ITEM: 6.5	REPORT SUMMARY MINOR VARIANCE APPLICATION FILE NUMBER A016/25
------------------	--

MINOR VARIANCE APPLICATION FILE NUMBER A016/25

CITY WARD #:	1
APPLICANT:	Rosetta & Dino Cantisano
AGENT:	Daniel Ferraro (Pent-Haus Studio Inc.)
PROPERTY:	137 Cherhill Drive, Maple
ZONING DESIGNATION:	See Below
VAUGHAN OFFICIAL PLAN (2010) DESIGNATION:	Vaughan Official Plan 2010 ('VOP 2010'): "Low-Rise Residential"
RELATED DEVELOPMENT APPLICATIONS:	N/A
PURPOSE OF APPLICATION:	Relief from the zoning by-law is being requested to permit the construction of a roof to cover the existing deck in the rear yard.

1 SITE PLAN
3/32" = 1'-0"

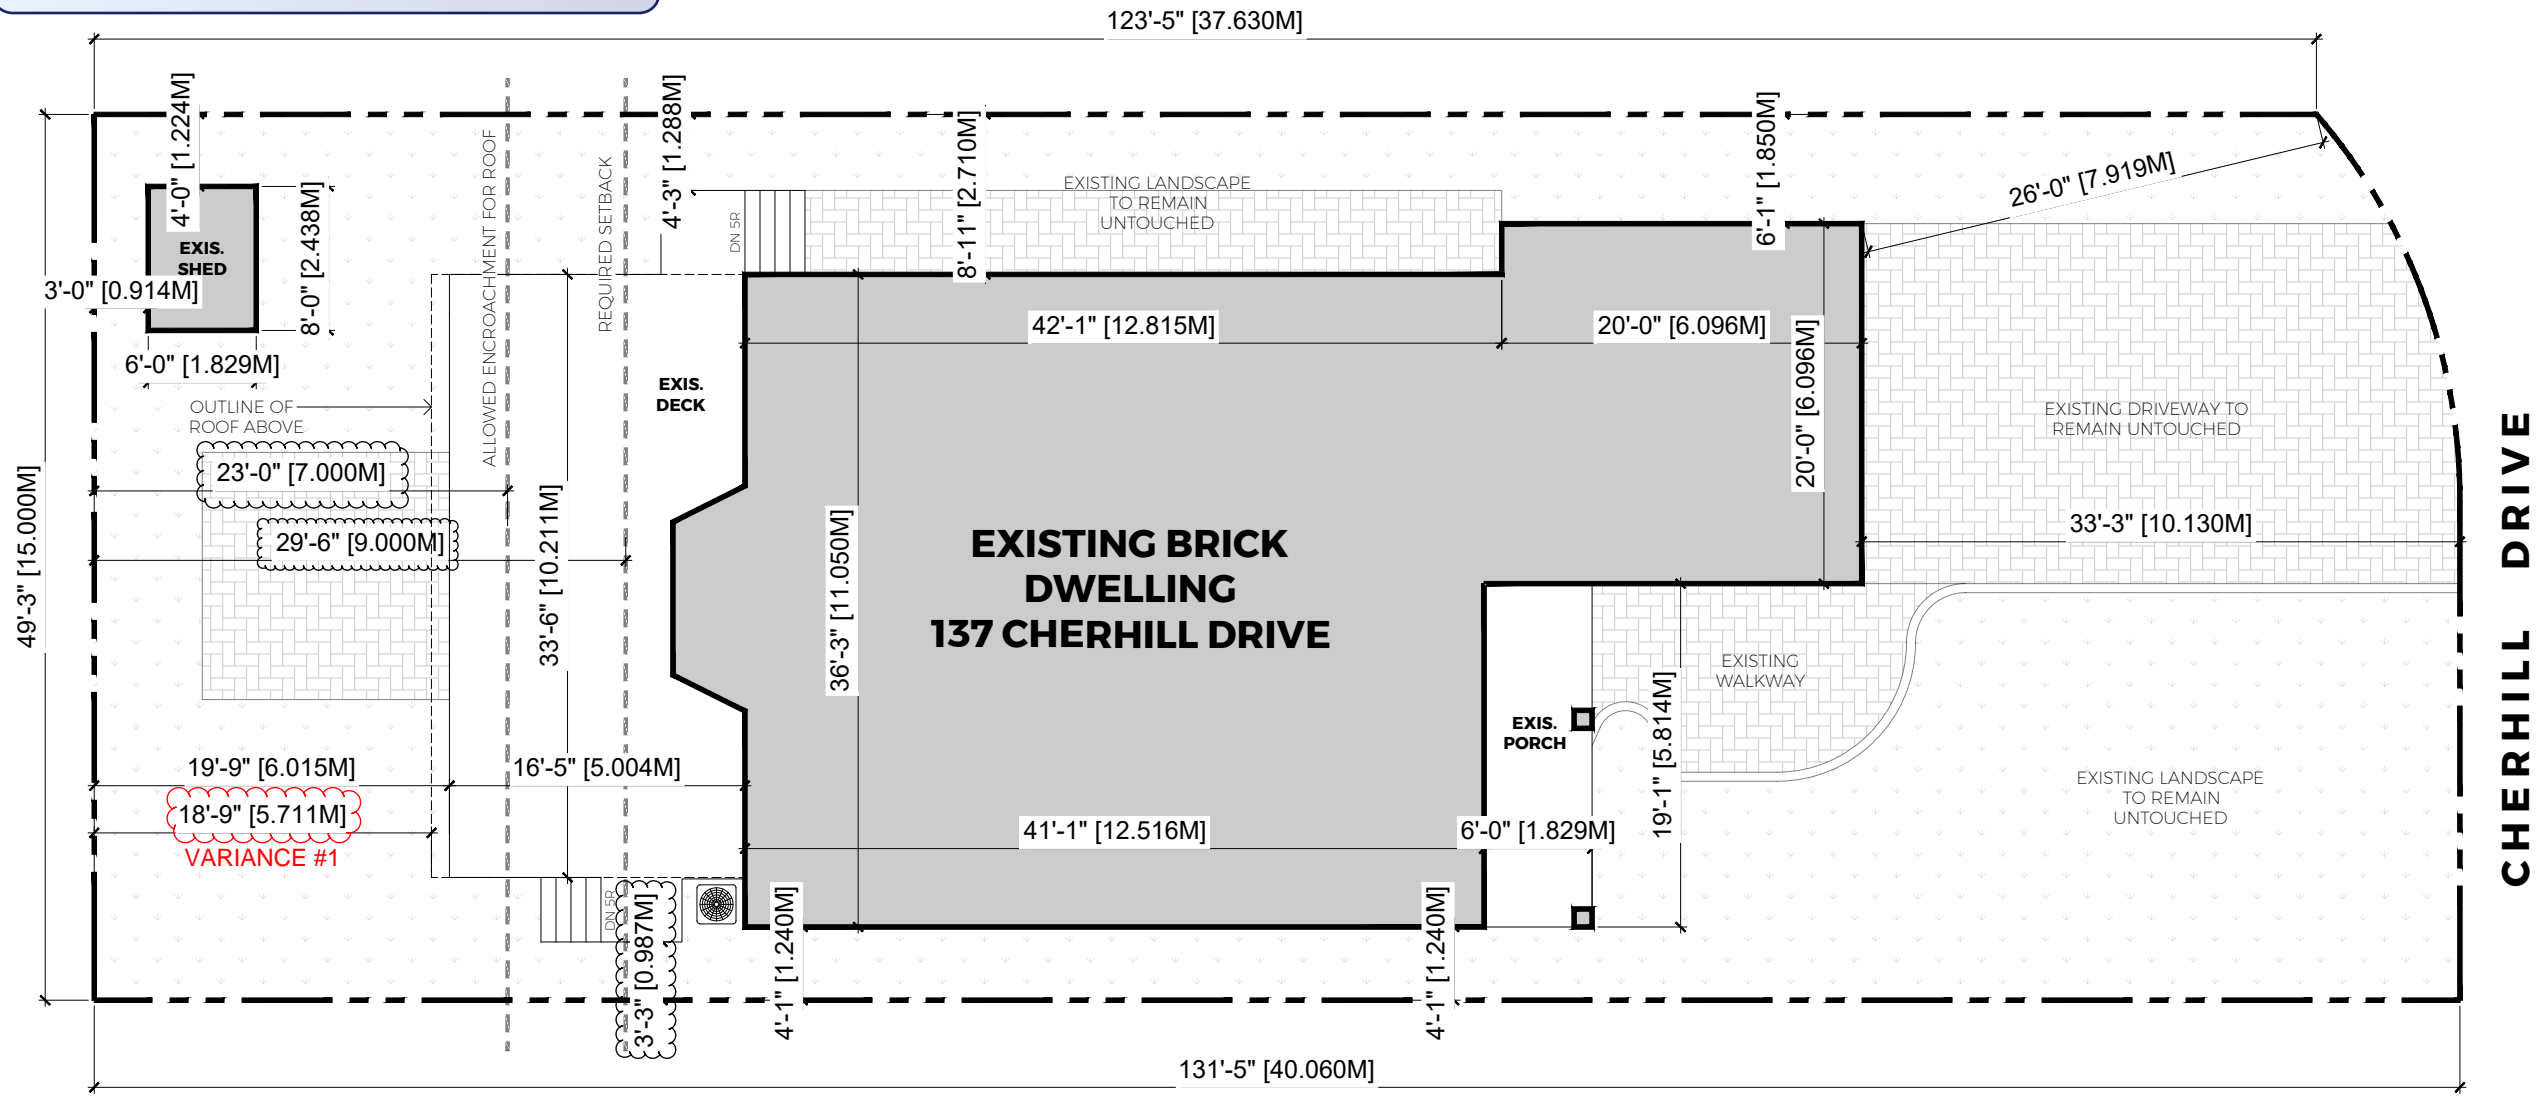
The Development and Parks Planning Department has no objection to Variance 1 to permit an encroachment of 3.3m for a porch into the rear yard, whereas the Zoning By-law permits 2.0 m. The existing deck has a height of 0.99 m and is attached to the rear wall of the existing single detached dwelling. The proposed 3.3 m encroachment does not hinder the functionality of the rear yard as an outdoor amenity space. The modest size and design of the deck is not anticipated to cause any adverse massing impacts to the surrounding properties.

The Development and Parks Planning Department has no objection to Variance 2 to permit a lot coverage of 41.81% to accommodate the covered deck, whereas the Zoning By-law permits 40%. The increase of 1.81% is minimal in nature and reflects appropriate development of the lands.
